**RE: CONTRACT NO.: 13/WSD/17
DESIGN, BUILD AND OPERATE FIRST STAGE OF TSEUNG KWAN O
DESALINATION PLANT
Submission of Detailed Design Plan for Chlorine and Carbon Dioxide Storage
of Desalination Plant**

Detailed Design Plan for Chlorine and Carbon Dioxide Storage of Desalination Plant

**First Stage of Desalination Plant at Tseung Kwan O – Investigation, Design and Construction
Detailed Design Plan for Chlorine and Carbon Dioxide Storage of Desalination Plant
IEC Verification Letter**

Submission No.	TKOD1-RPT-A000-JGN0003-04		
Subject	Submission of Detailed Design Plan for Chlorine and Carbon Dioxide Storage of Desalination Plant	Date	9/07/2021
Version	04	Page	1 of 2

©COPYRIGHT RESERVED

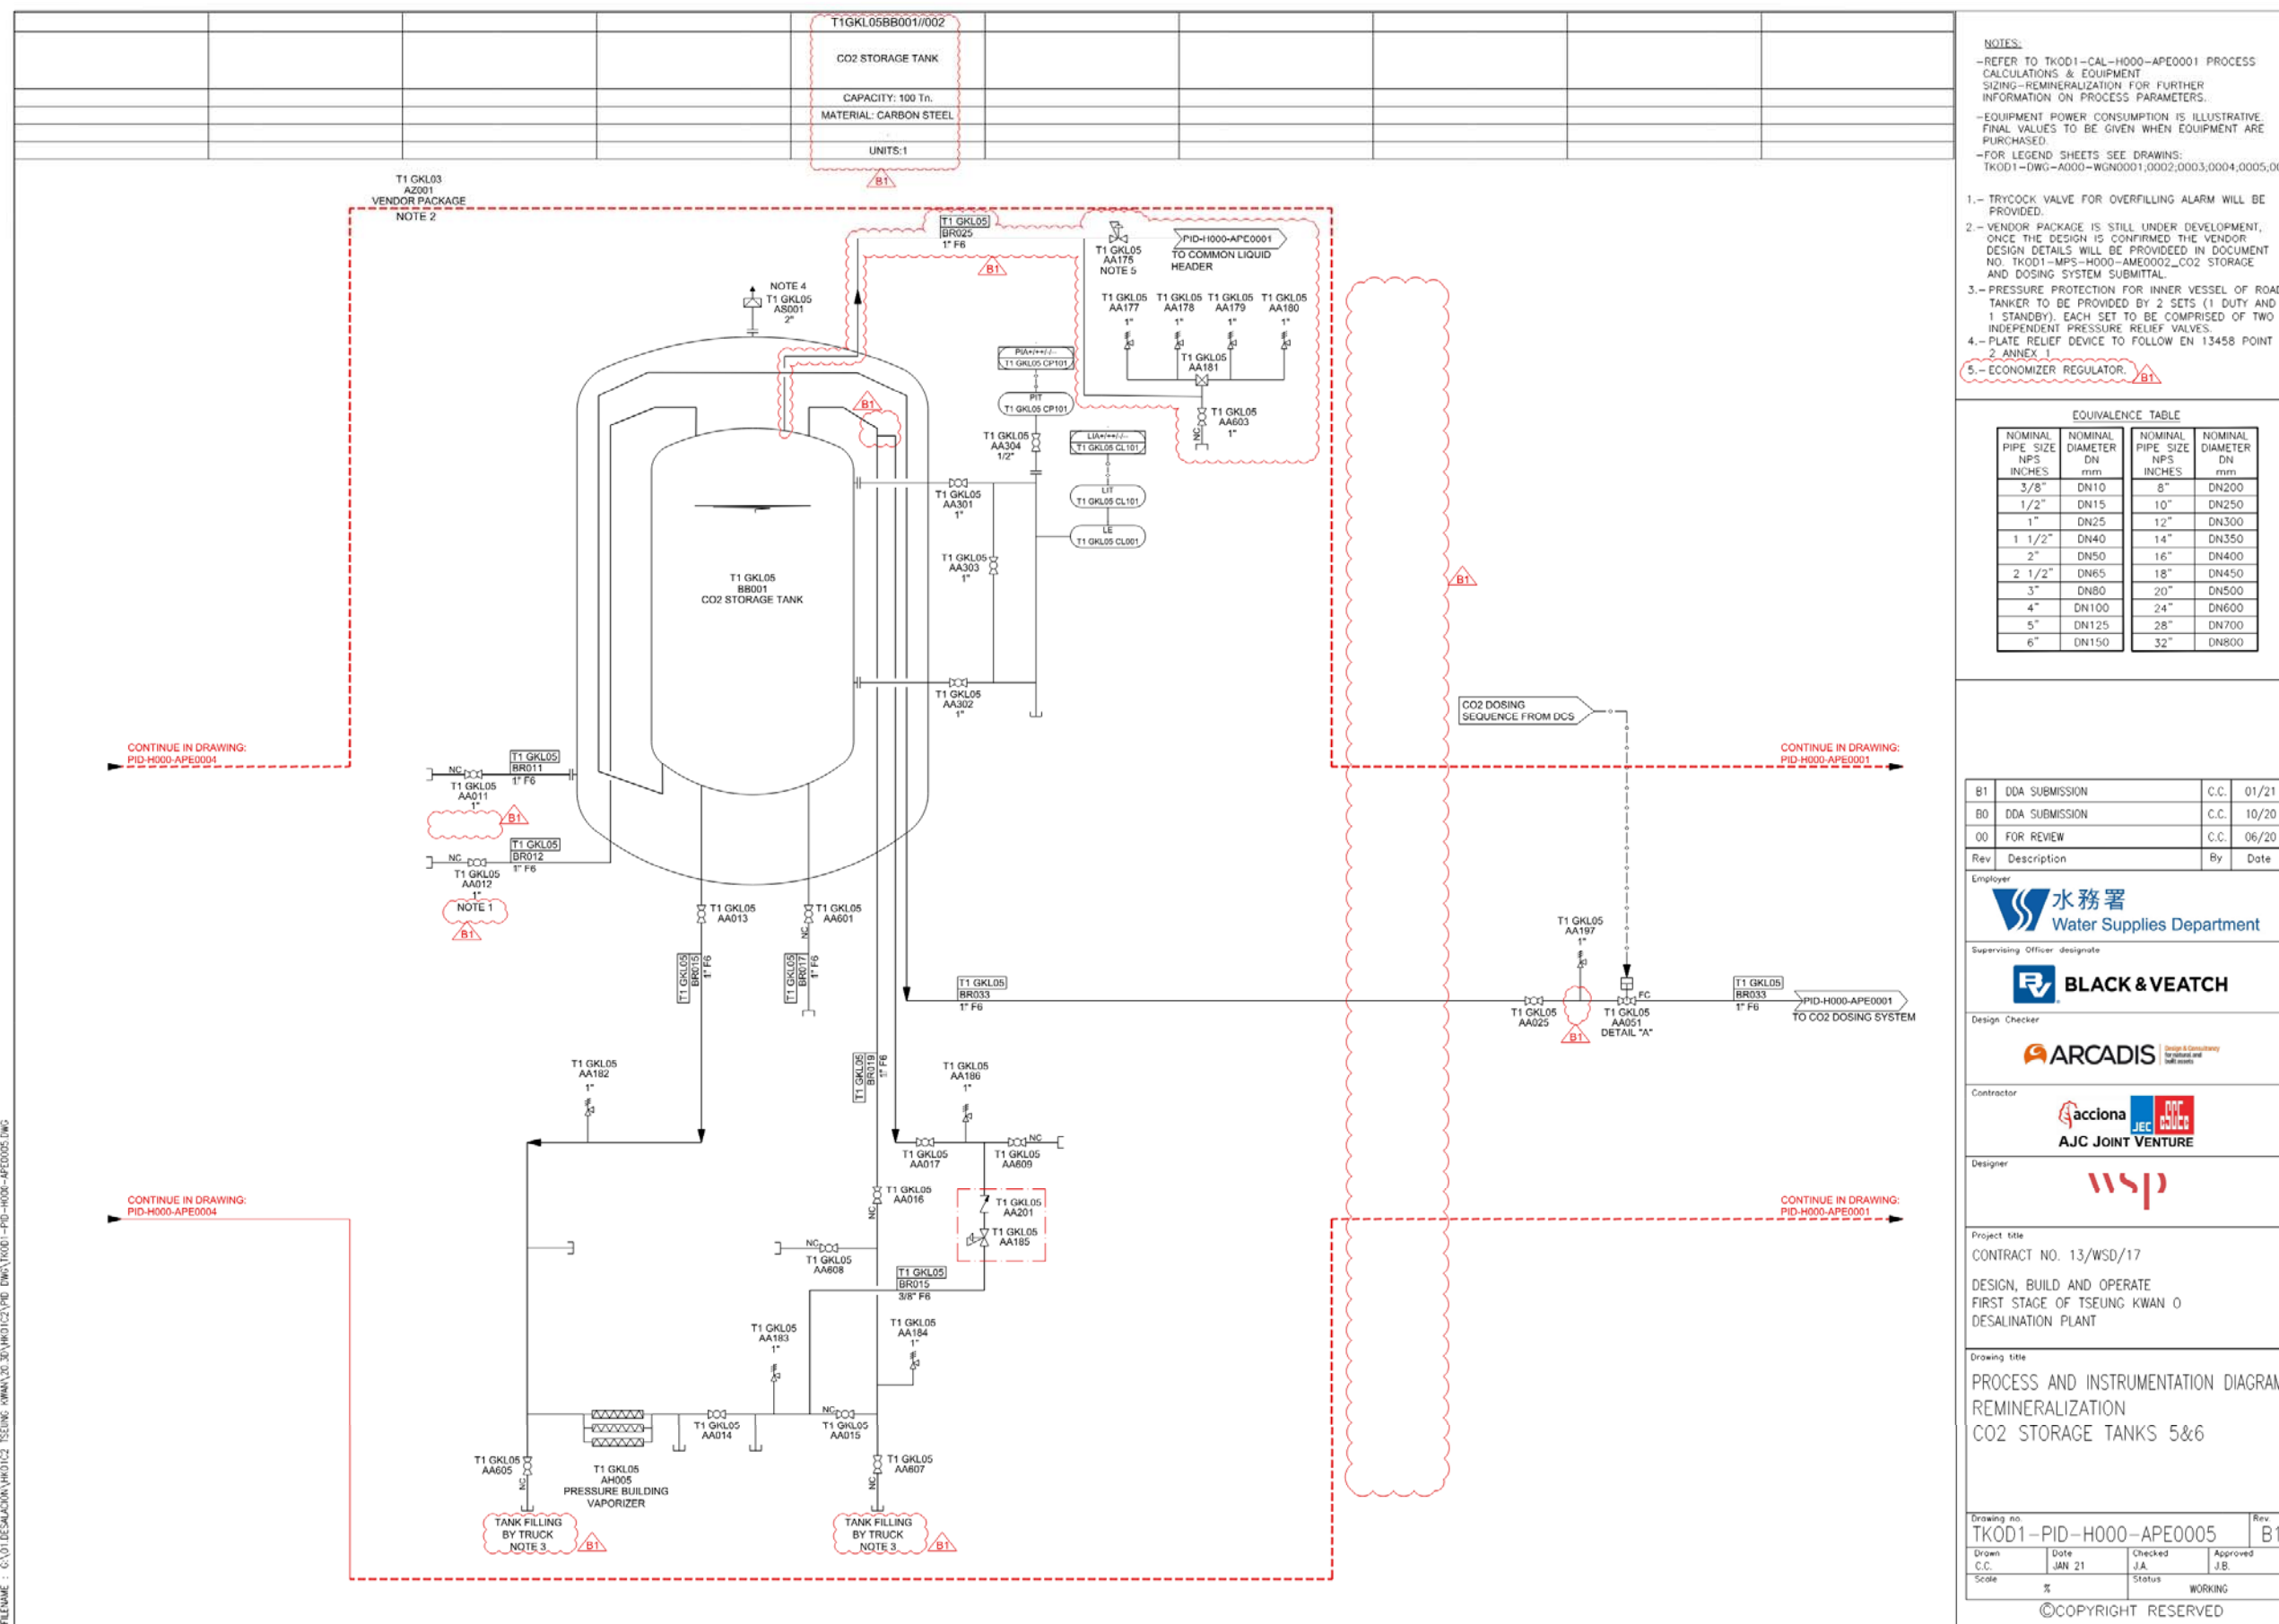
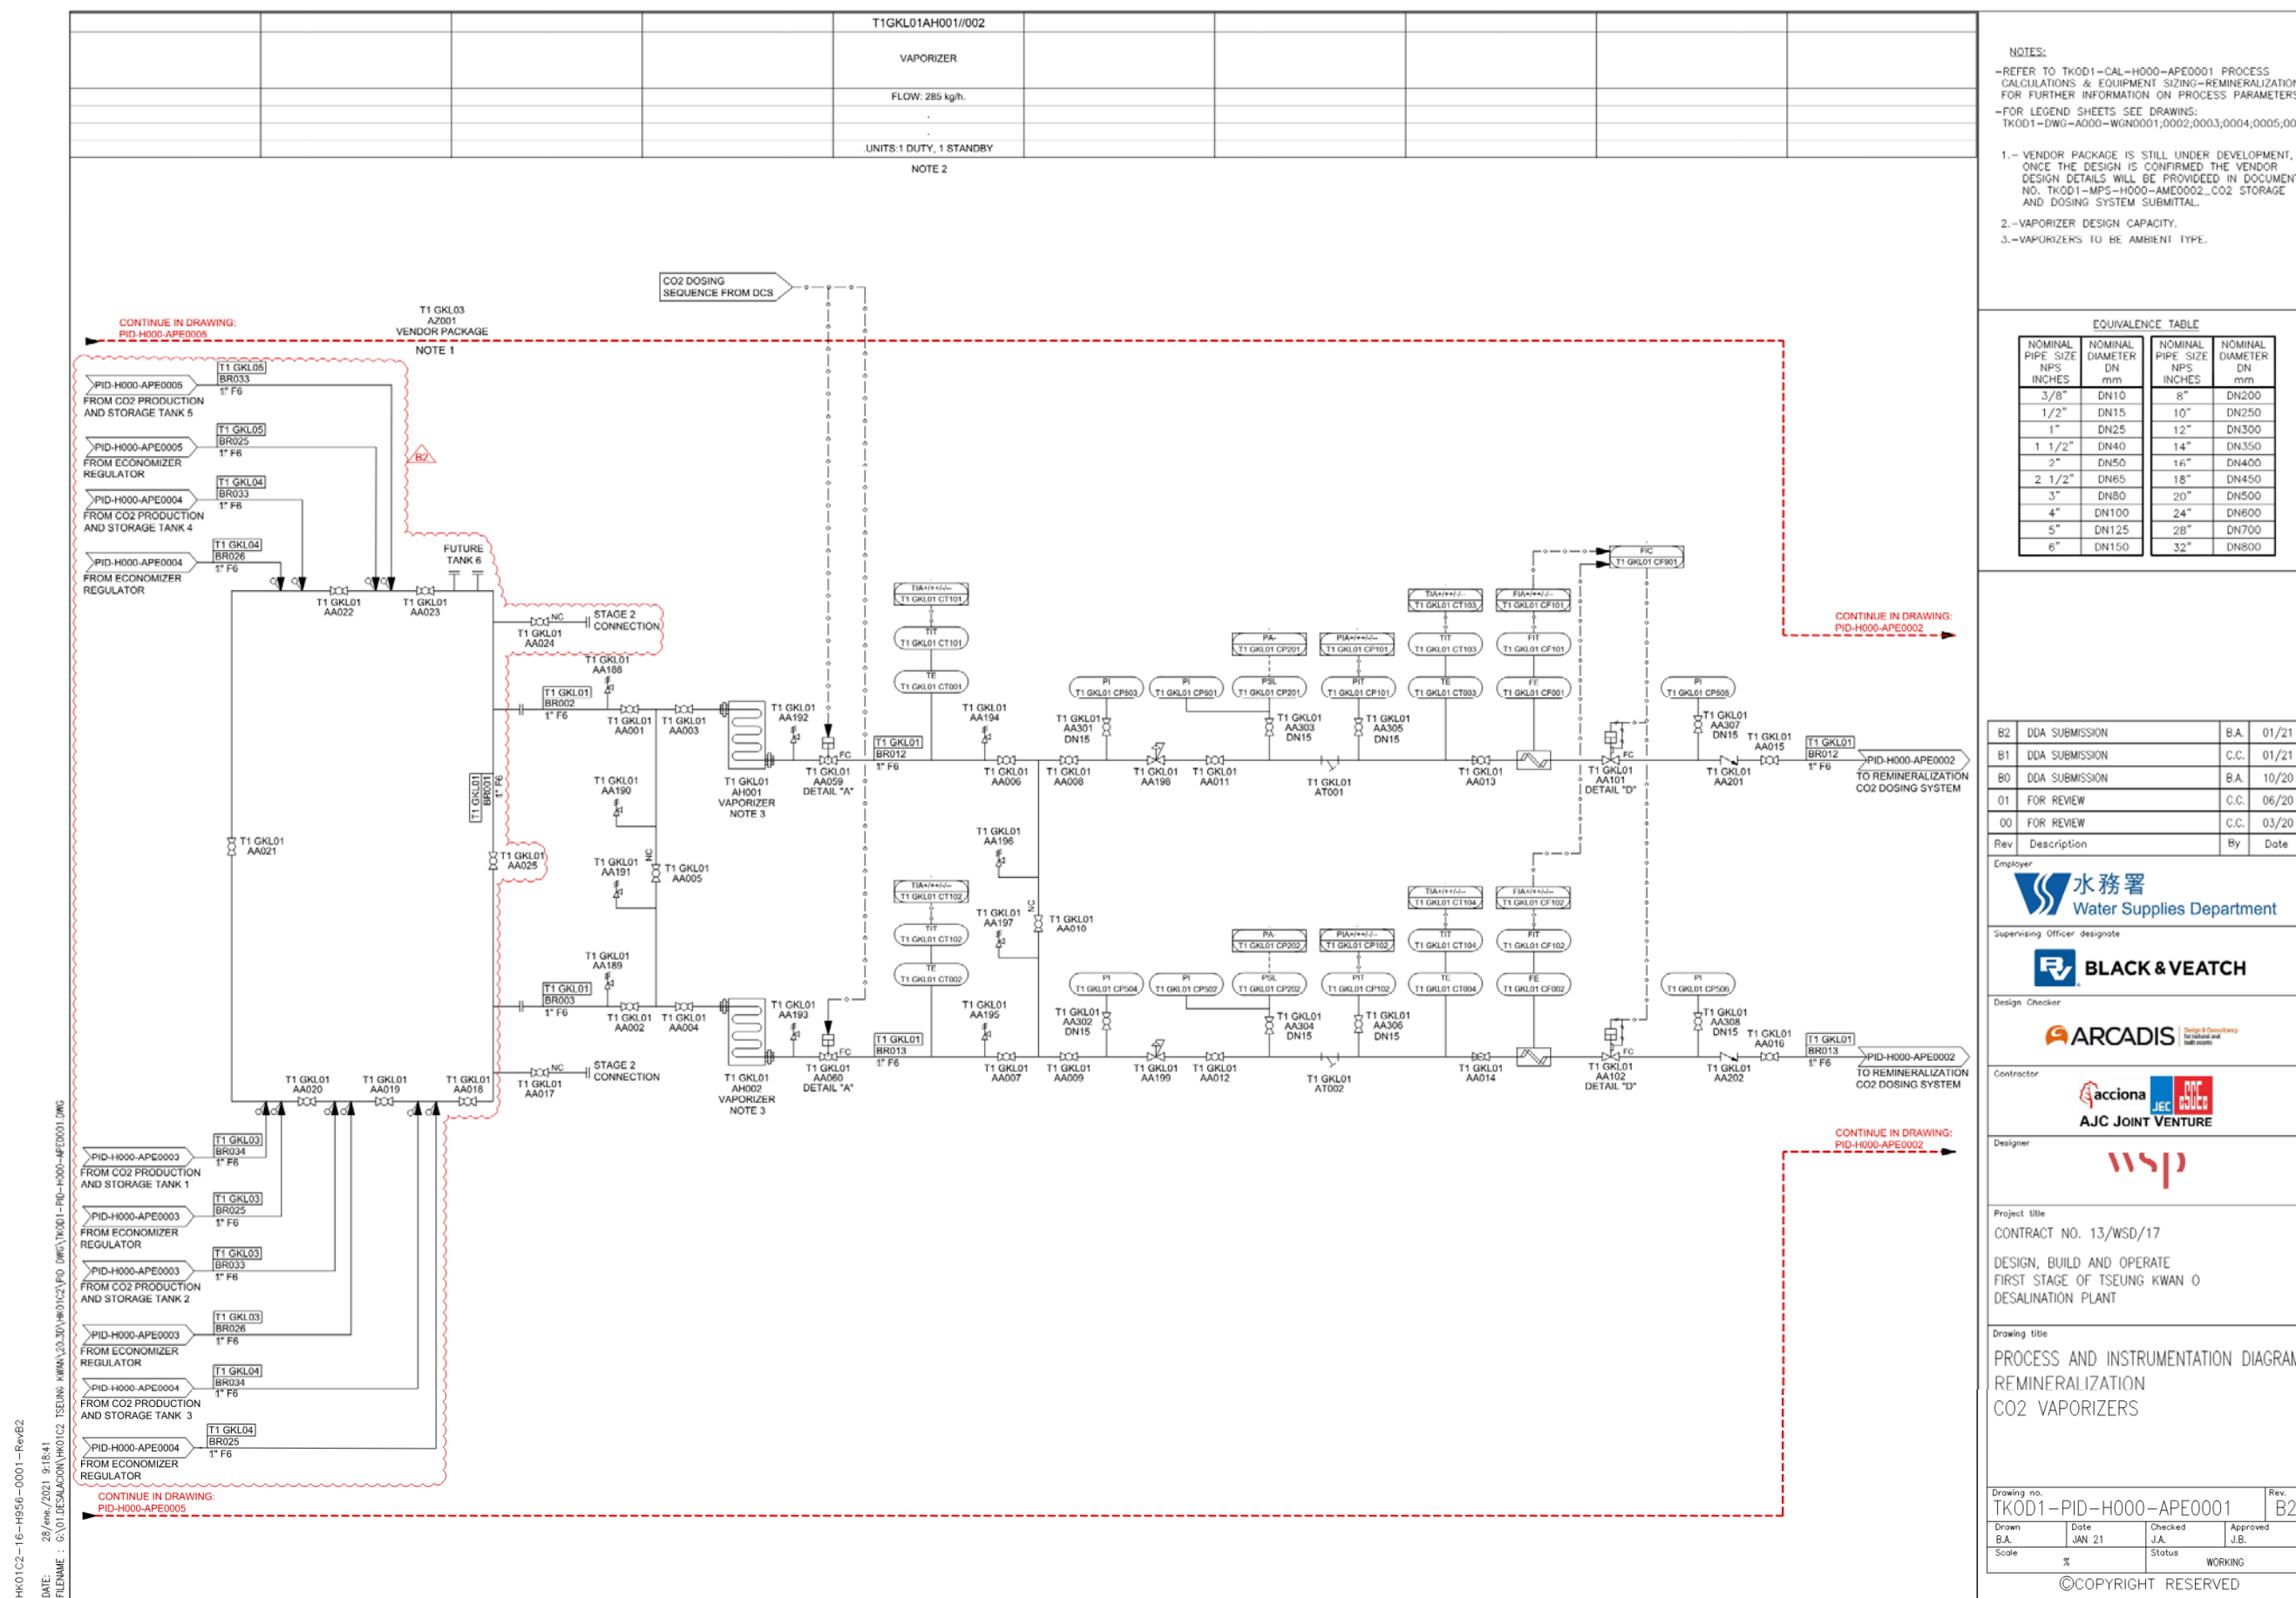
2. Appendix B Please explain how the design of the pressure relief valves system can avoid common mode failure.	Explanation has been added in Appendix B-5 of the revised plan. The P&IDs in Appendix B-2 have also been revised.
